UNITED STATES
DEPARTMENT OF THE INTERIOR
BUREAU OF LAND MANAGEMENTFORM APPROVED
OMB NO. 1004-0137
Expires: January 31, 2018**SUNDRY NOTICES AND REPORTS ON WELLS**
Do not use this form for proposals to drill or to re-enter an abandoned well. Use form 3160-3 (APD) for such proposals.5. Lease Serial No.
NMNM25448

☒ Oil Well ☐ Gas Well ☐ Other8. Well Name and No.
BISTI GALLUP 20 22. Name of Operator
DJR OPERATING LLCContact: SHAW-MARIE FORD
E-Mail: sford@djrlc.com9. API Well No.
30-045-33944-00-S13a. Address
1600 BROADWAY SUITE 1960
DENVER, CO 802023b. Phone No. (include area code)
Ph: 505-632-347610. Field and Pool or Exploratory Area
BISTI LOWER GALLUP

Plug and Abandonment Procedure
for
DJR Operating, LLC
Bisti Gallup 20-2
API # 30-045-33944
NW/NE, Unit B, Sec. 20, T25N, R12W
San Juan County, NM

BLM FLUID MINERALS Geologic Report

Current Wellbore Diagram
DJR Operating, LLC
Bisti Gallup 20-2
API # 30-045-33944
NW/NE, Unit B, Sec 20, T25N, R12W
San Juan County, NM

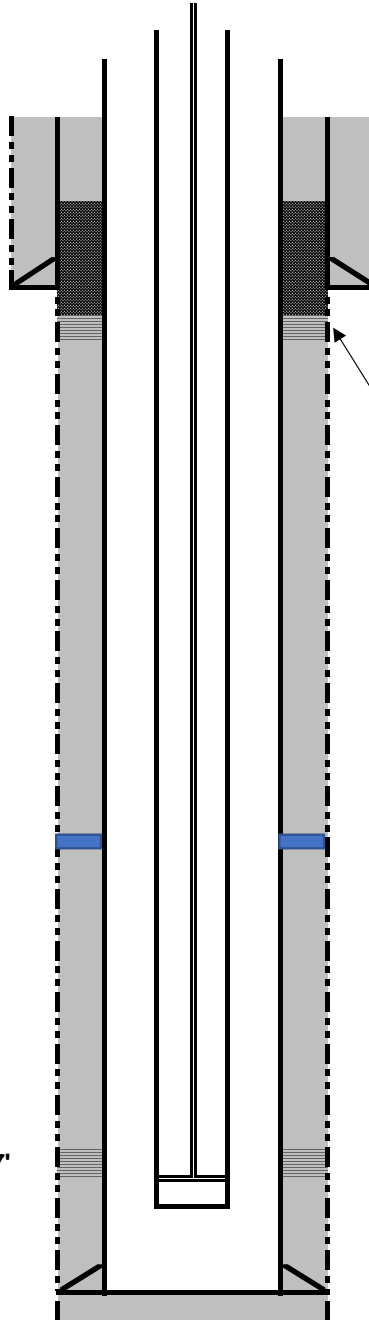
- Please ensure that the tops of the Pictured Cliffs and Fruitland formations, as well as the entire Ojo Alamo aquifer, identified in this report, are isolated by proper placement of cement plugs. This will protect the freshwater sands in this well bore.

- The top of the Ojo Alamo formation is behind the surface casing. The proposed plugging plan will adequately protect the freshwater sands in this formation.

- Please note that the BLM geologist's pick for the Menefee formation varies slightly from the operator's pick and the Menefee is encountered twice, above and below the Cliff House.
